CITY OF COCONUT CREEK

Development Review Committee Agenda
Submittal Deadline Date: August 9, 2022
Meeting Date: September 8, 2022

DEVELOPMENT REVIEW COMMITTEE (DRC) REVIEW #1 – SEPTEMBER 7, 2022

PROJECT NAME:	Gunther Mitsubishi		
PROJECT NUMBER:	PZ-22080004		
LOCATION:	4300-4350 N State Road 7		
APPLICANT/AGENT:	Stiles Architecture		
REVIEW/APPLICATION:	PMDD Site Plan		
DISCIPLINE	REVIEWER	EMAIL	TELEPHONE
DRC Chair	Liz Aguiar - Principal Planner	laguiar@coconutcreek.net	(954) 973-6756
Urban Design & Development			
Urban Design, Photometrics & Sustainability	Linda Whitman - Senior Planner	lwhitman@coconutcreek.net	(954) 973-6756
Urban Design & Signage	Natacha Josiah - Planner	njoshia@coconutcreek.net	(954) 973-6756
Transportation	Michael Righetti - Senior Project Manager	mrighetti@coconutcreek.net	(954) 973-6756
Building	Sean Flanagan - Deputy Building Official	sflanagan@coconutcreek.net	(954) 973-6750
Engineering	Eileen Cabrera - Senior Engineer	ecabrera@coconutcreek.net	(954) 973-6786
Fire	Ryan Banyas - Fire Marshal	rbanyas@coconutcreek.net	(954) 956-1563
Landscape	Scott Peavler - Landscape (consultant)	speavler@craventhompson.com	(954) 739-6400

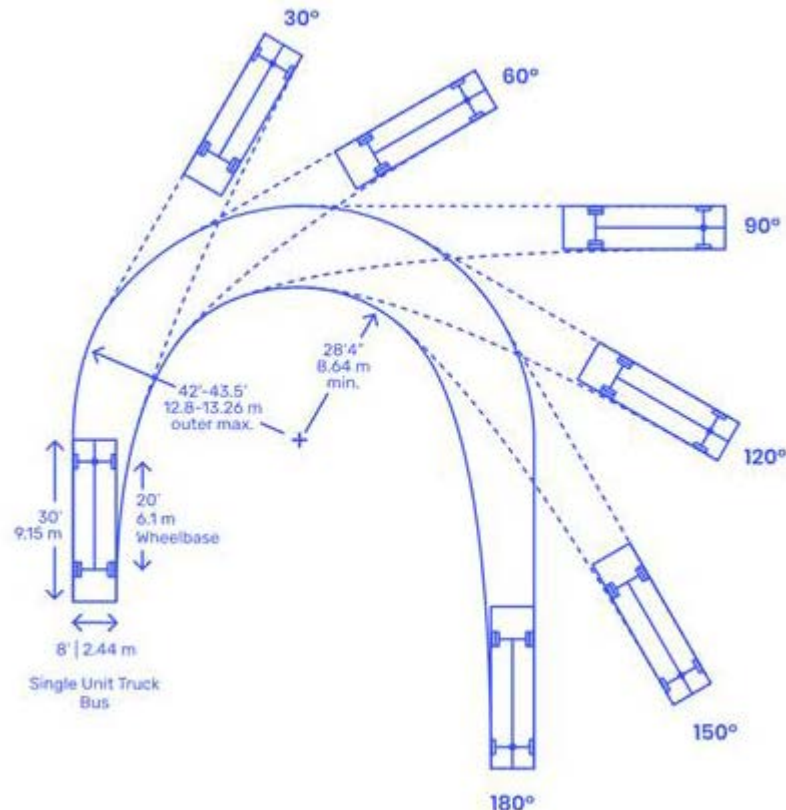
1. The Fire Truck Route Plan shall show turning radius dimensions.
2. A vehicle's turning circle is the radius (or diameter) measured by the outer wheels of the vehicle while making a complete turn, without any physical conflicts (i.e. curbs, light poles, fire hydrants, etc.);
3. A minimum inner turning radius of 28'4" | 8.64 m should be provided for a bus or single-unit truck making a 180° turn.
4. The turning path of a City Fire Truck measures the minimum possible turning radius necessary for performing a *U-turn* in a vehicle with a 20' (6.1 m) wheelbase.
5. Measuring the inner and outer radii of the 180° turn, a minimum inner radius of 28'4" (8.64 m) and minimum outer radius between 42'-43.5' (12.8-13.26 m) should be provided for City Fire Trucks;

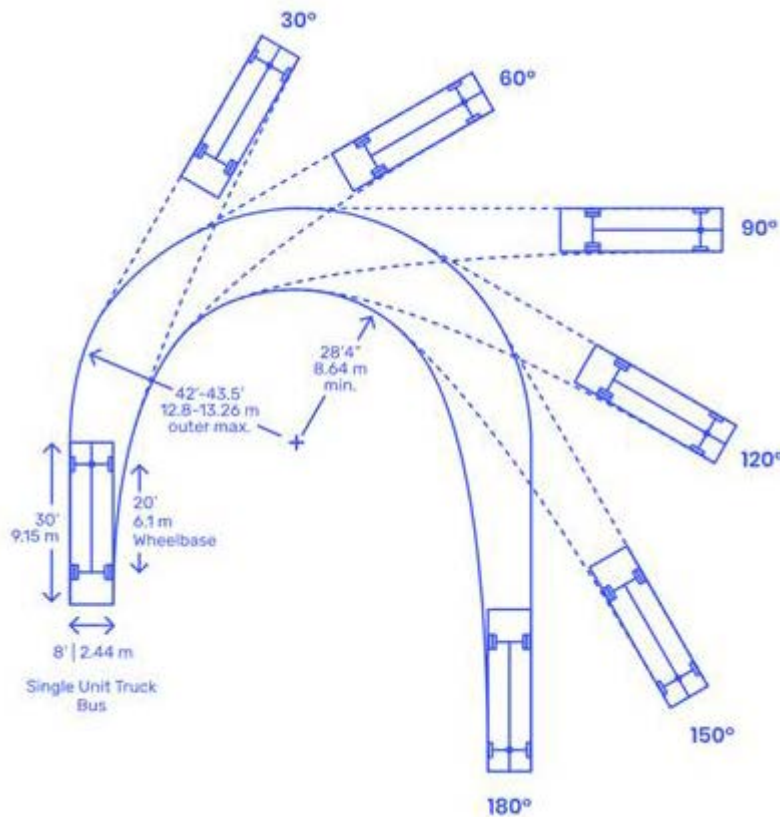
The Fire Truck Route Plan shall show turning radius dimensions.

A vehicle's turning circle is the radius (or diameter) measured by the outer wheels of the vehicle while making a complete turn, without any physical conflicts (i.e. curbs, light poles, fire hydrants, etc.);

A minimum inner turning radius of 28'4" | 8.64 m should be provided for a bus or single-unit truck making a 180° turn.

2. The turning path of a City Fire Truck measures the minimum possible turning radius necessary for performing a *U-turn* in a vehicle with a 20' (6.1 m) wheelbase.
3. Measuring the inner and outer radii of the 180° turn, a minimum inner radius of 28'4" (8.64 m) and minimum outer radius between 42'-43.5' (12.8-13.26 m) should be provided for City Fire Trucks;

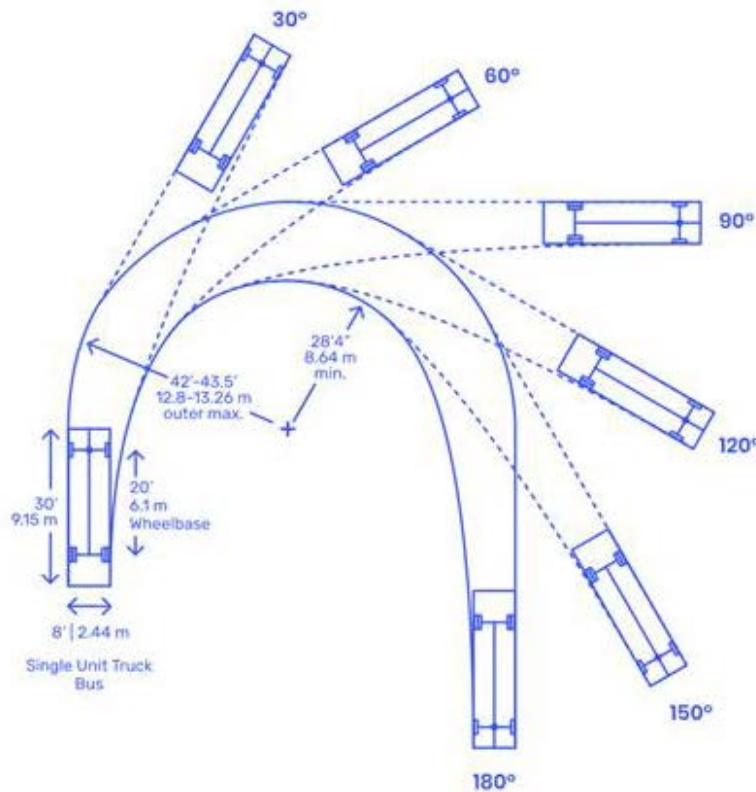
A minimum inner turning radius of 28'4" | 8.64 m should be provided for a bus or single-unit truck making a 180° turn.

The turning path of a City Fire Truck measures the minimum possible turning radius necessary for performing a U-turn in a vehicle with a 20'6" (6.1 m) wheelbase.

Measuring the inner and outer radii of the 180° turn, a minimum inner radius of 28'4" (8.64 m) and minimum outer radius between 42'-43.5; (12.8-13.26 m) should be provided for City Fire Trucks;
